**MANDATORY  
SERVICE BULLETIN**

DATE: March 10, 1978 Service Bulletin No. 412B  
(Supersedes Service Bulletin No. 412A)  
Engineering Aspects are  
FAA (DER) Approved

SUBJECT: Intake and Exhaust Valve Rocker Arm Retaining Stud

MODELS AFFECTED: O-320-H series serial numbers L-101-76 to L-2182-76 inclusive.

Figure 1. View Showing Interior of Rocker Arm

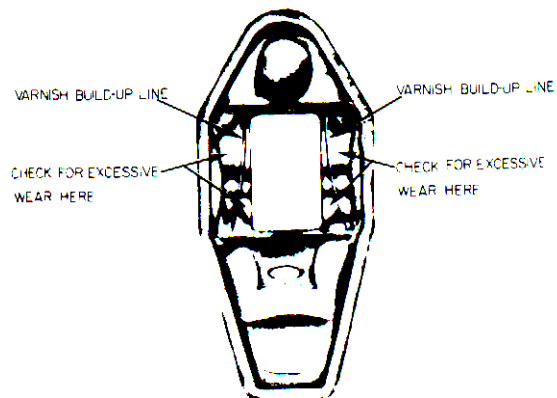
2. Inspect the fulcrum seating surface in the rocker arm. See figure 1. The surface will show a polish or burnishing which occurs during break-in of the engine. This is normal and not a cause for replacement. However, a developed wear step of more than .003 inch is considered excessive wear and would require replacement of the rocker arm. Do not interpret varnish build-up lines on the seating surface of the rocker arm as wear.

Figure 2. Cylinder Showing Valve Rocker Assembly

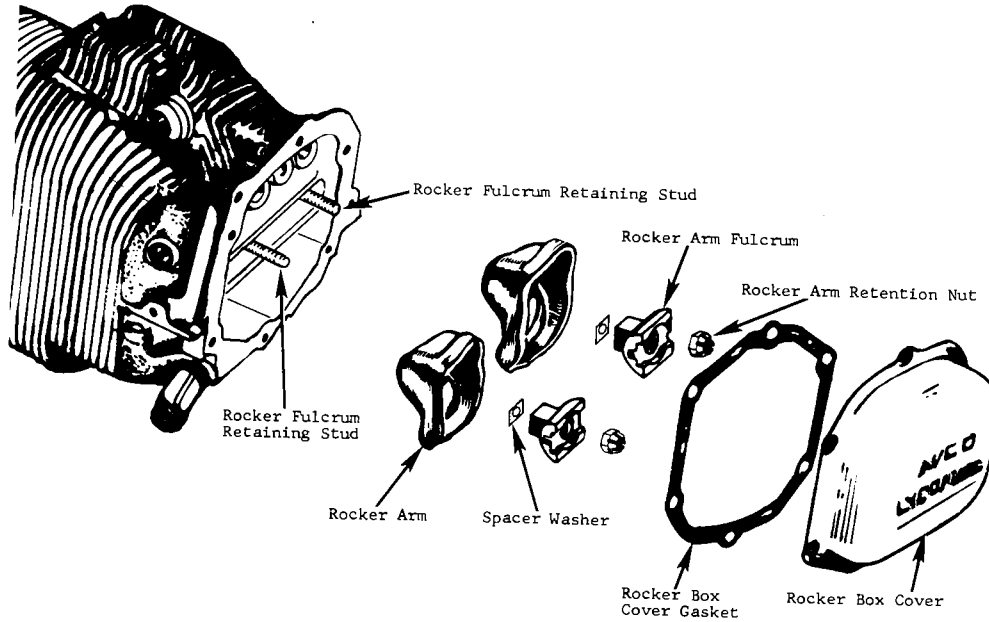
6. Reassemble push rods, spacer washers, rocker arm and fulcrum in their original locations as outlined in the caution note. See figure 2. Torque rocker arm retaining nut to 150 inch pounds. Prior to installing rocker box covers, rotate crankshaft and observe for proper functioning of valve gear.
